Gate Burton Energy Park EN010131

Outline Design Principles (Change Request Version)
Document Reference: EN010131/APP/2.3

Revision <u>54</u> October 2023

Environmental Parameters Plan

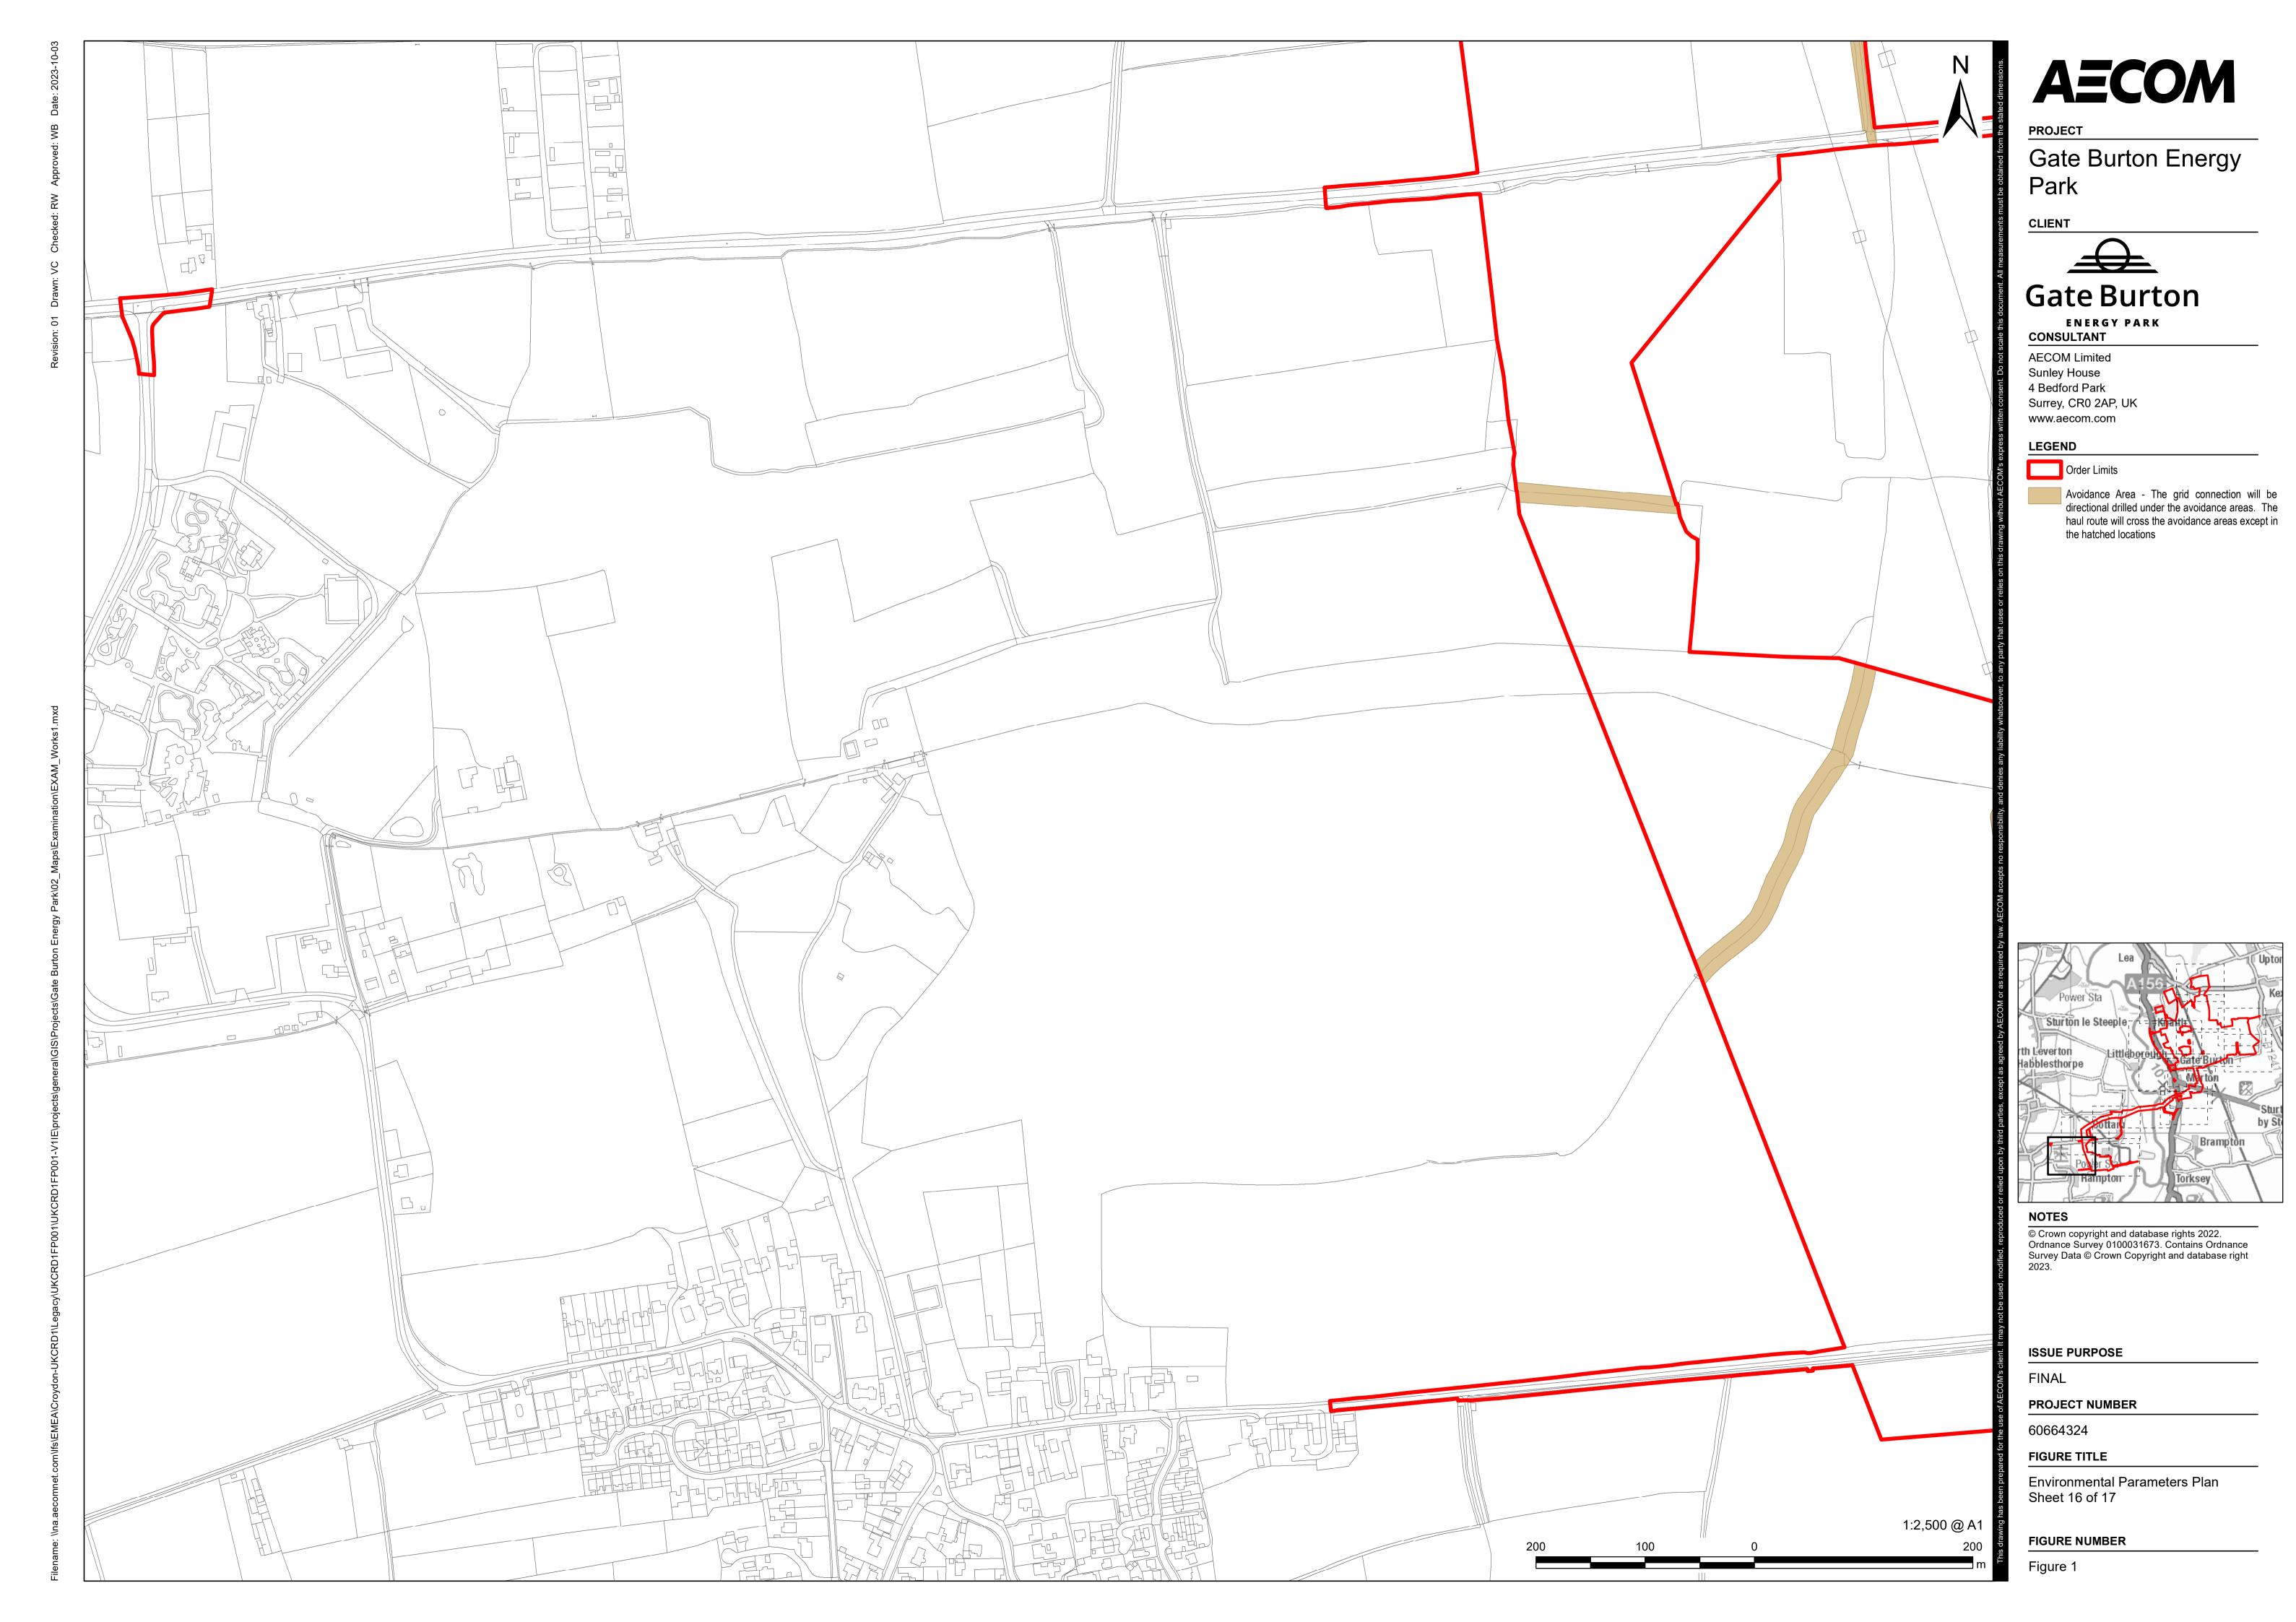
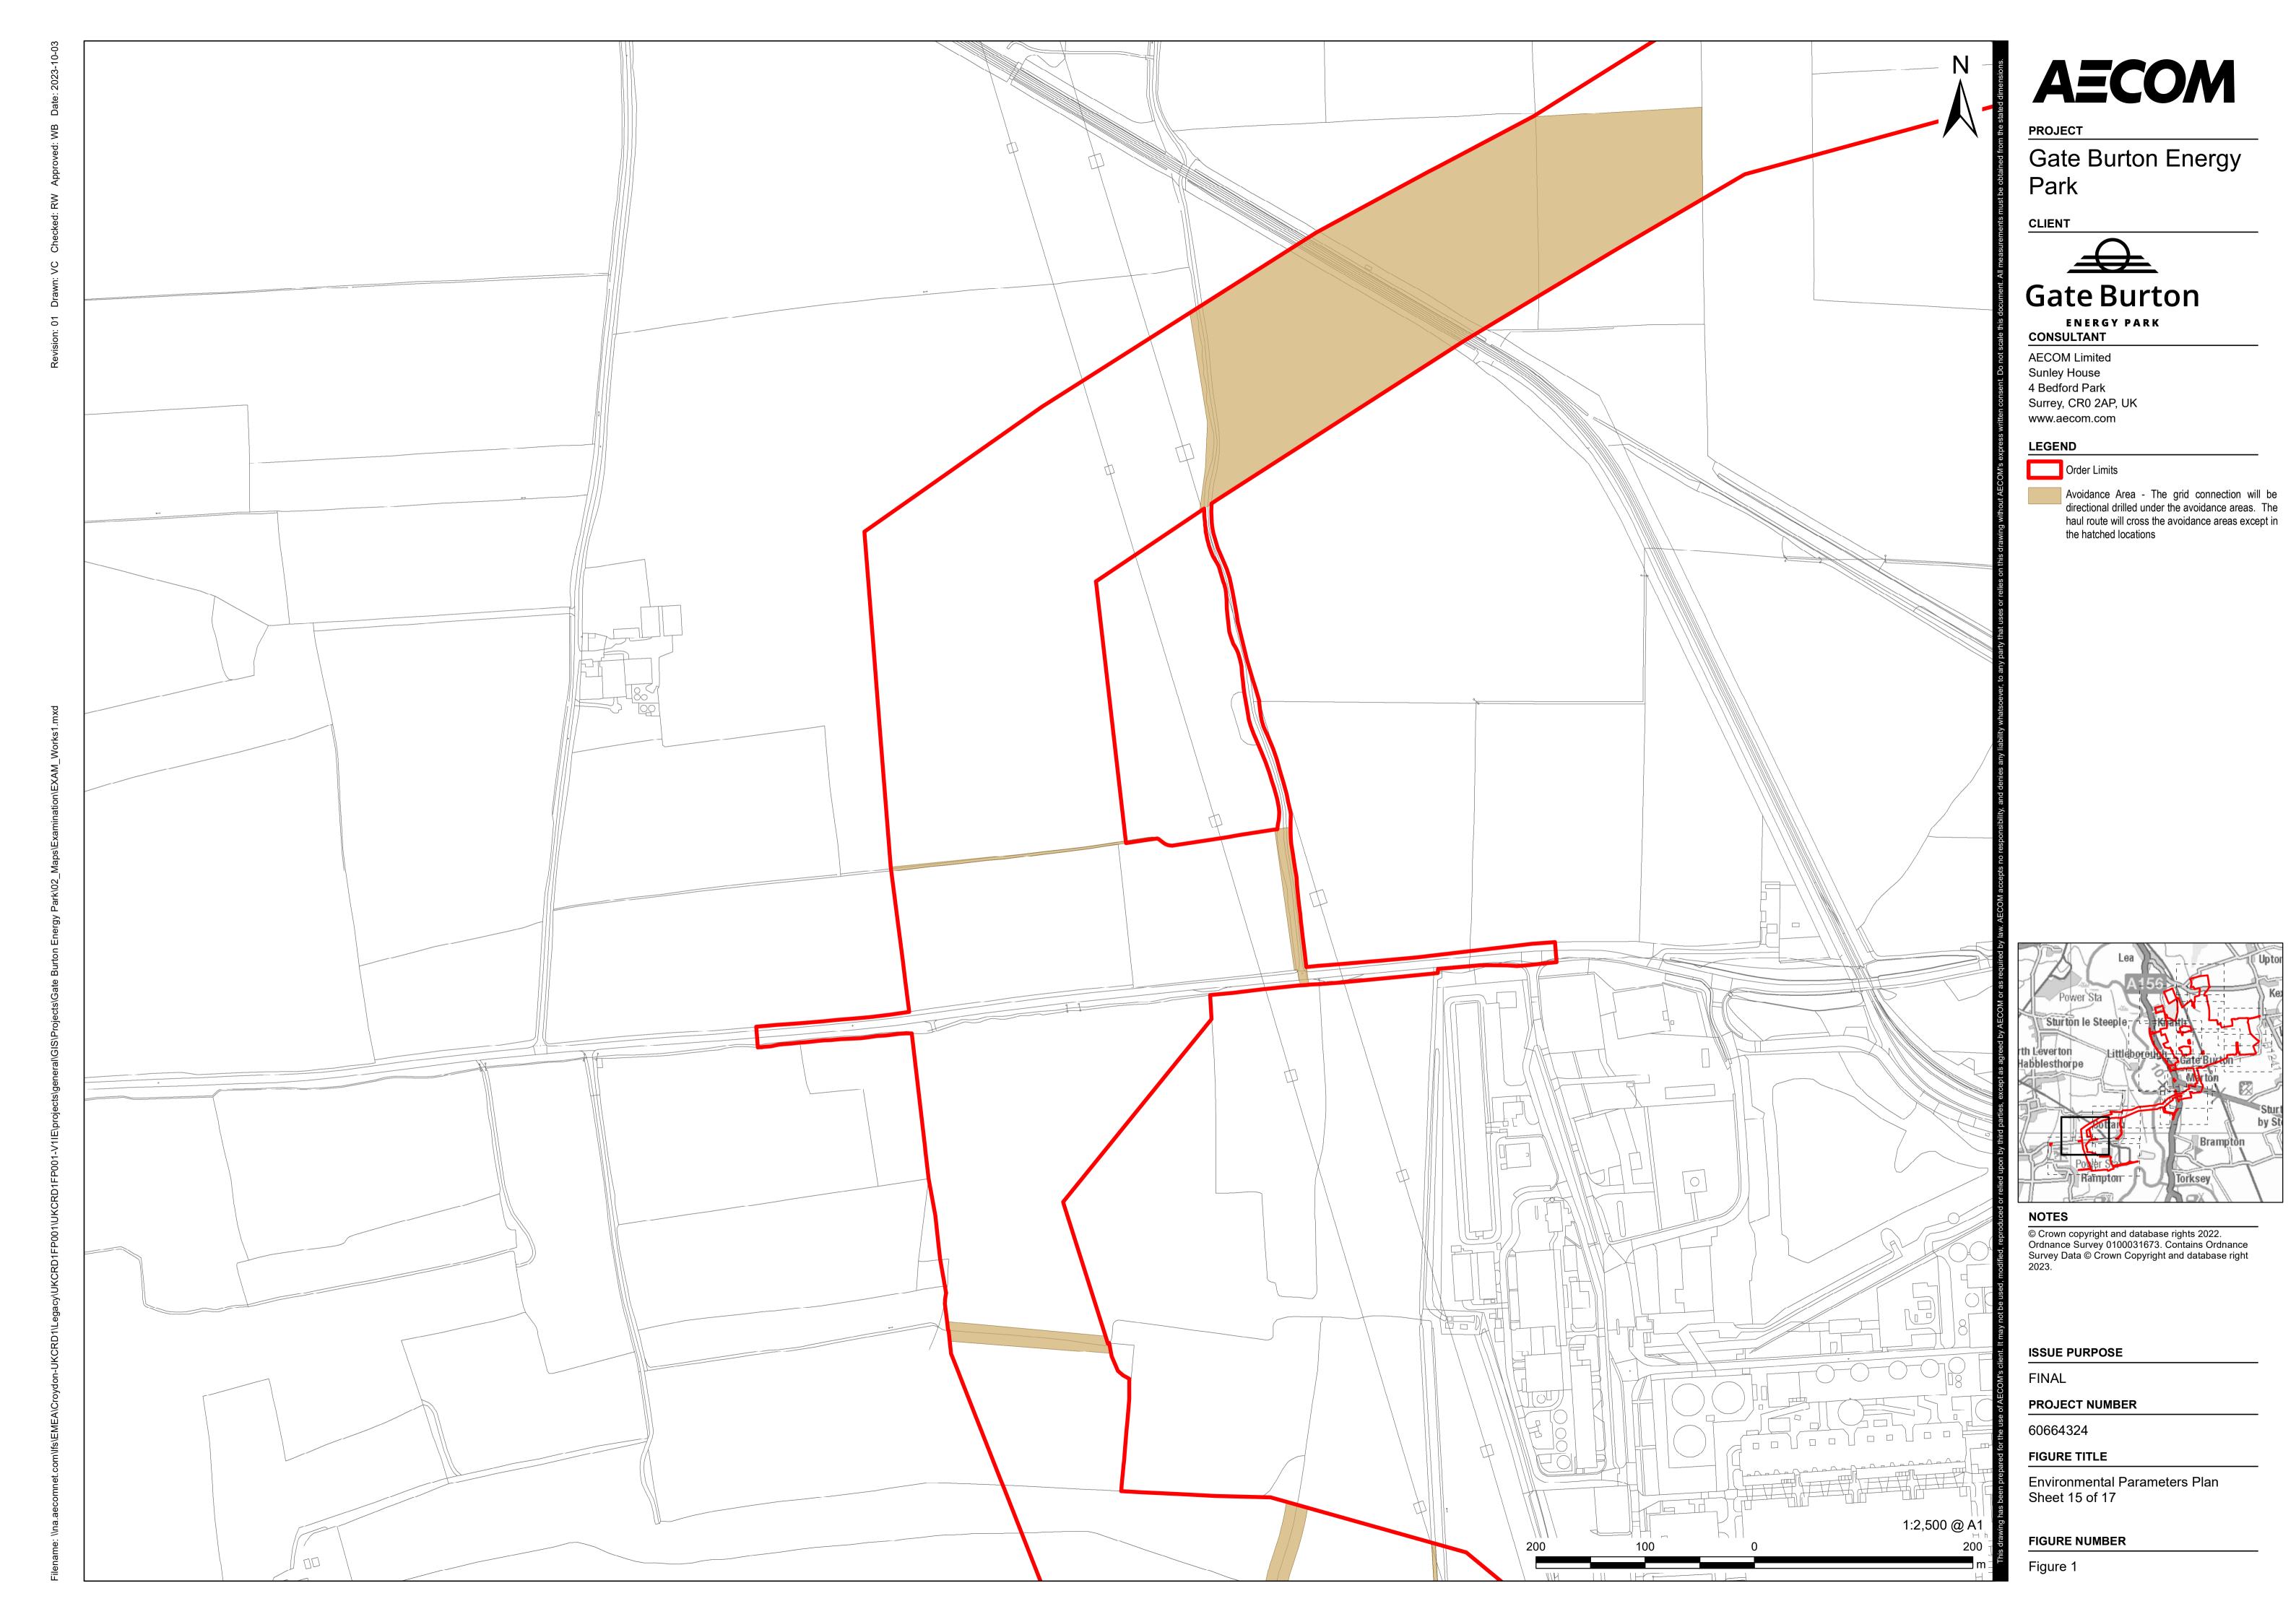
1.1.4 As part of design development, the location of the water tanks have been relocated such that they are adjacent to the access road, at the request of Lincolnshire Fire and Rescue Service. The new locations are outside the area that may be affected by the prevailing wind direction. The Parameter Plan Figure has been amended to include the additional areas for the water tanks. The maximum height of the water tanks is 4.57m. The northern water tank is adjacent to the BESS envelope which has a maximum height of 4.5m. The southern water tank is adjacent to the substation envelope which has a maximum height of 13m. The relevant environmental assessments (landscape and visual, ecology and nature conservation, water environment and cultural heritage) have reviewed the change The change does not have an impact on the conclusions of the assessments as set out within the Environmental Statement.
